Groundwater & Wastewater Services
Septic Project File & Data Review Worksheet

GWS File #: 2624B WASPS App #: 3233

# SOIL/SITE EVALUATION for ON-SITE WASTEWATER SYSTEM

**Attached is a proposed design for an Accepted (25% reduction) Septic System with Pressure Manifold distribution for a 6 bedroom single family residence on Lot # 53 Abersham Subdivision, Mecklenburg County, North Carolina.** 7624B

☐ SURVEY PLAT TO SCALE SUBMITTED ☒ SCALED SITE PLAN SUBMITTED ☐ UN-SCALED SITE PLAN SUBMITTED

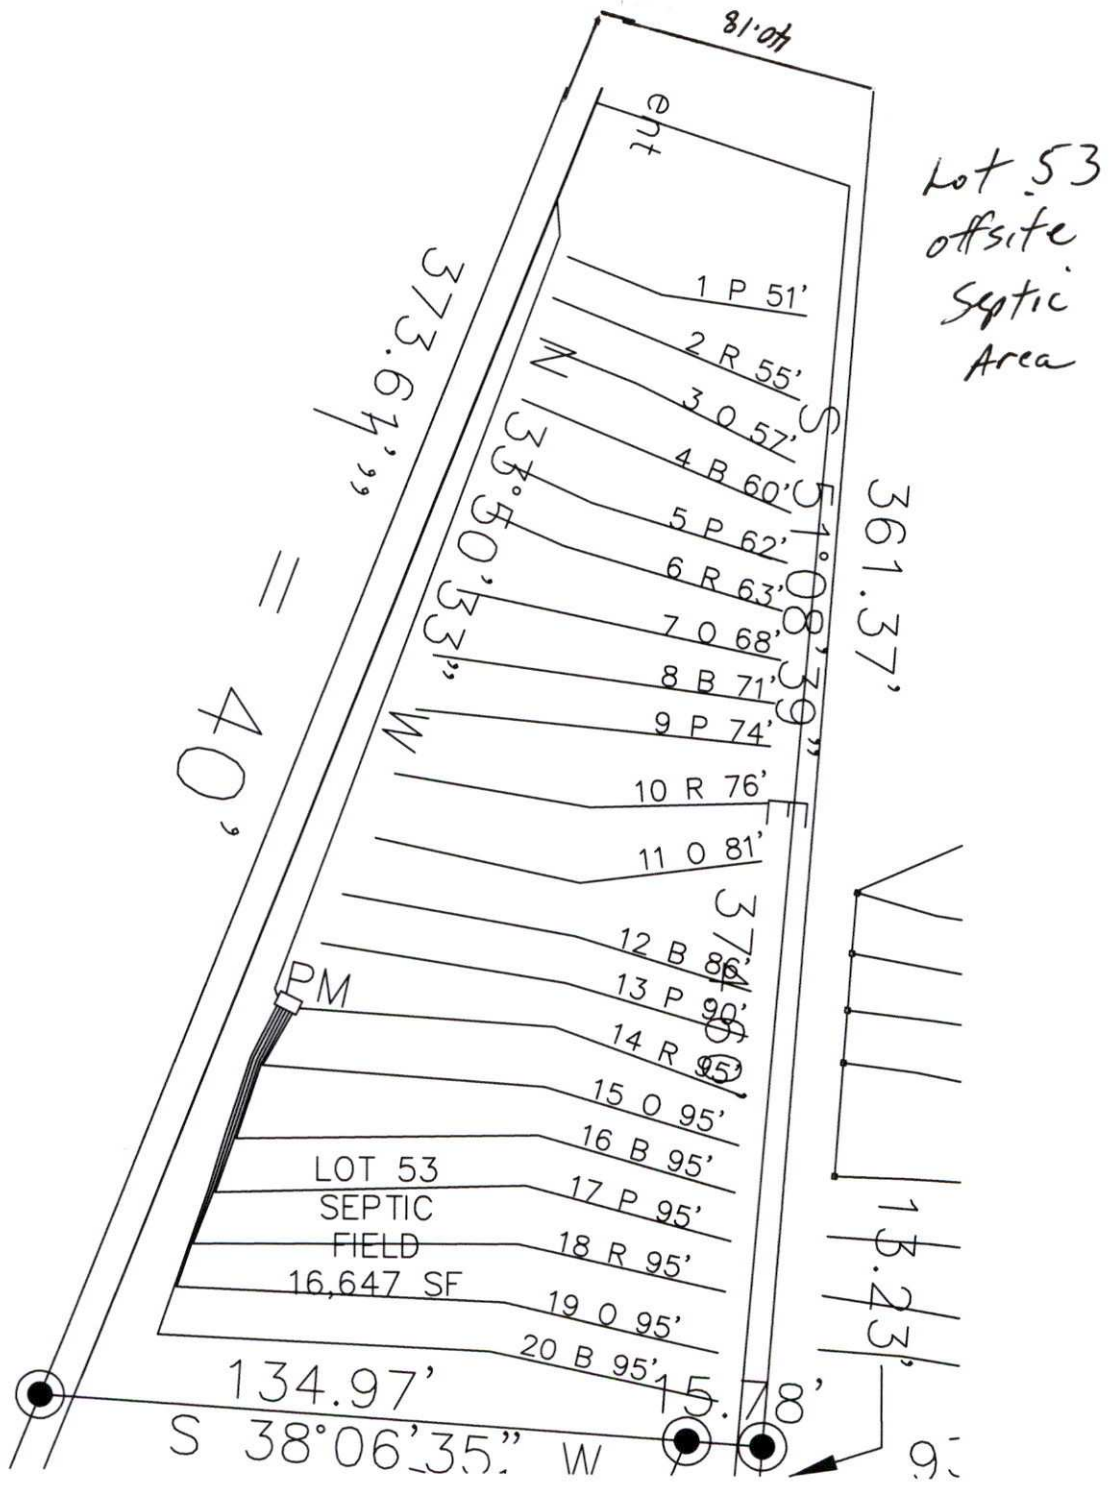
Give me a copy of plat to verify 31' prop. line
